INDESIT company

Model type:
TAN2S

Commercial code:
F034169

51421m0 Exploded views

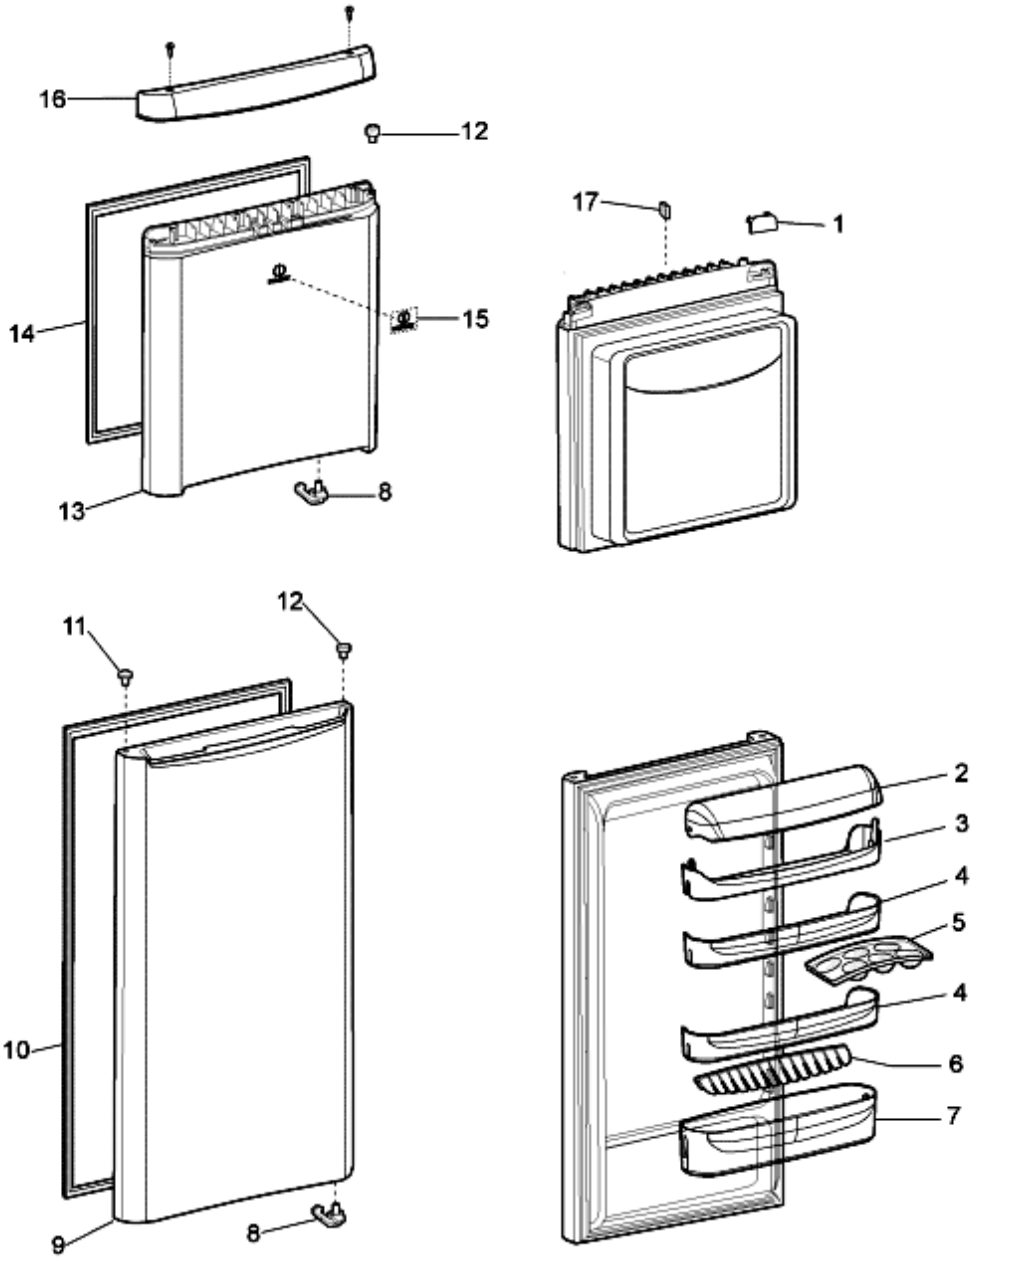
n2507b01: Color change on inner door upper heading

From s/n 70129.0001 (January 2007) on teak – inox – silver Indesit models has been introduction in production a new white inner door upper heading / white hinge blanking plate.

The spare part code of the door remain the same.

When replacing the door in the products produced before the modification replacing also the brown hinge blanking plate (for teak versions), grey (for silver version), aluminium (for inox versions) with the white.

n2511b02: ELIMINATION COVER FOR UPPER DOOR SHELF-INTERNAL ACCESSORIES RESTYLING

Cover for upper door shelf has been eliminated. The upper door shelf has been standardized with the middle one. Subsequently has been standardized with transparent internal accessories instead of those in light blue colour once stock has depleted.

n2512d01: BOTTLE HOLDER ELIMINATION

BOTTLE HOLDER HAS BEEN ELIMINATED FROM PRODUCTION

5142260 Exploded views

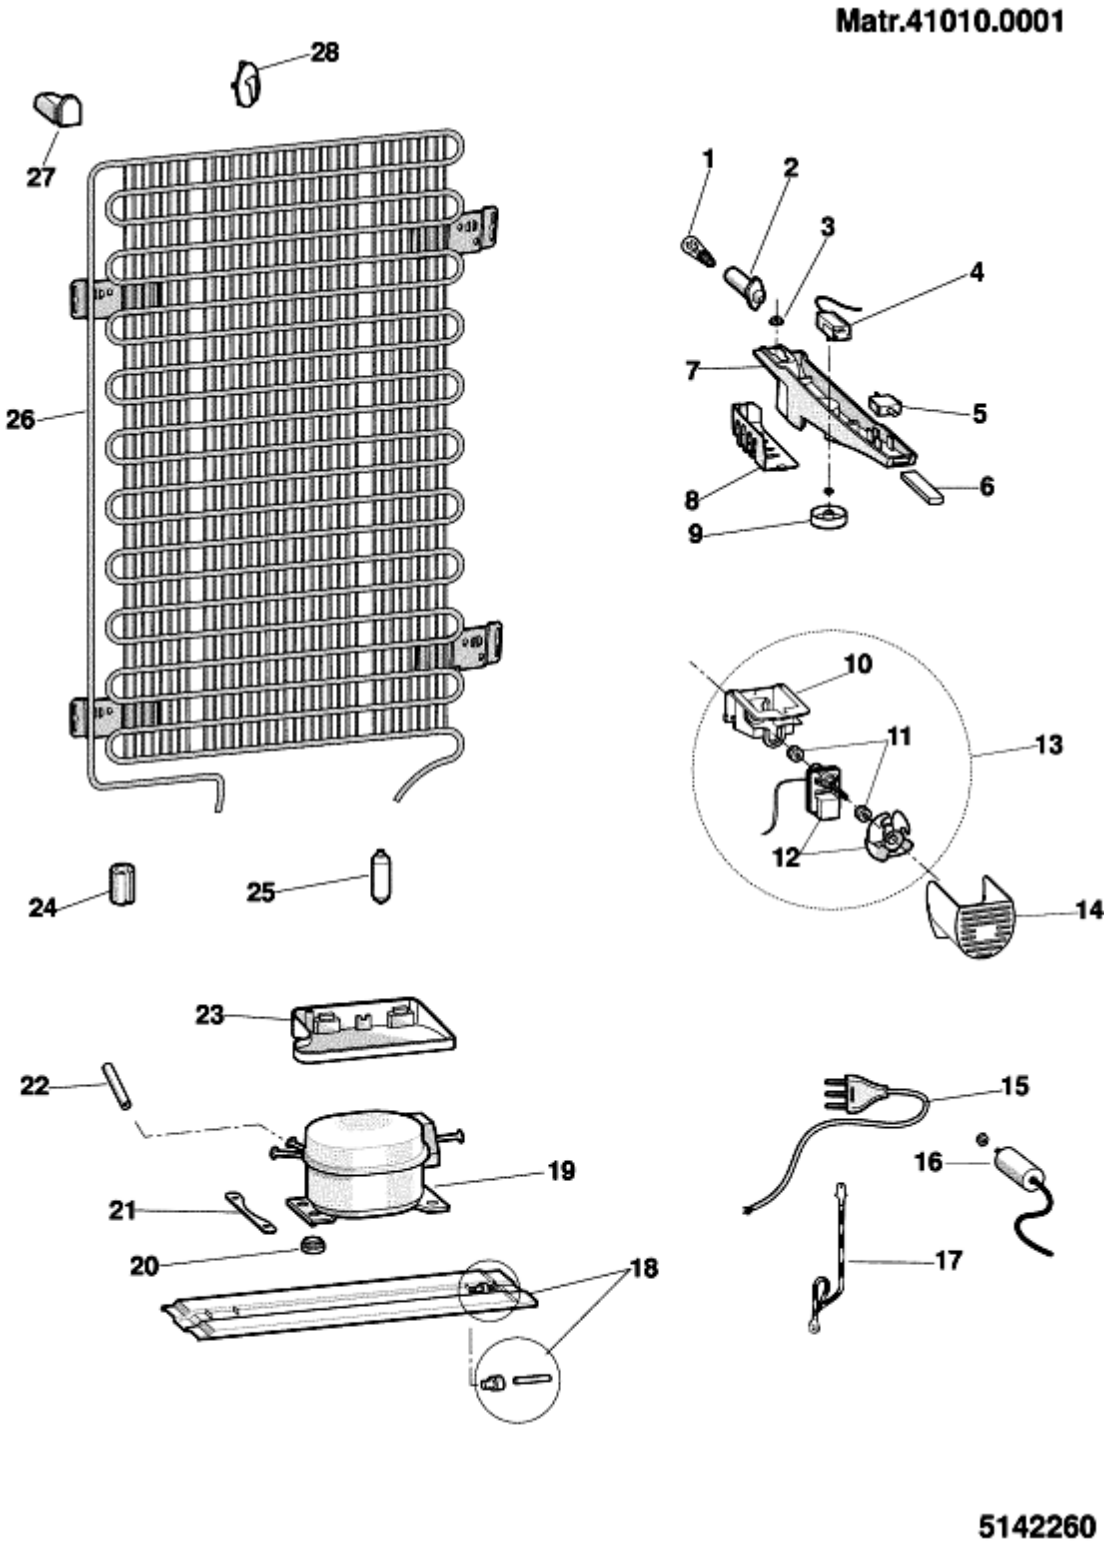
n1025135: Thermostat box on Indesit/Ariston Opera-60 refrigerators (low A.T. +16°C)

As of July 2003, two new "Low ambient temperature thermostat box kits" have been introduced as spare parts for Ariston Opera-60 and Indesit 2000 - 2002 - 2003 range refrigerators with Giugiaro thermostat box (075646).

The two kits have a different thermostat (remember to always check the position of the mark).

The kit must only be used to solve freezer performance problems caused by an ambient temperature below +16° C.
This innovative kit features a DIODE, activated by means of the luminous switch, which makes the thermostat box lamp turn on. It must be activated when the ambient temperature falls below +13°C (closed contacts: see the wiring diagram that comes with the kit).
The heat produced by the lamp activates the thermostat, thus ensuring regular operation of the appliance.
When replacing the thermostat box, no component can be reused (including the wiring).
The kit wiring has pin terminals for connection to the terminal block on the compressor; some modifications may be required for other solutions.
Given below is the list of kit items available as spare parts:
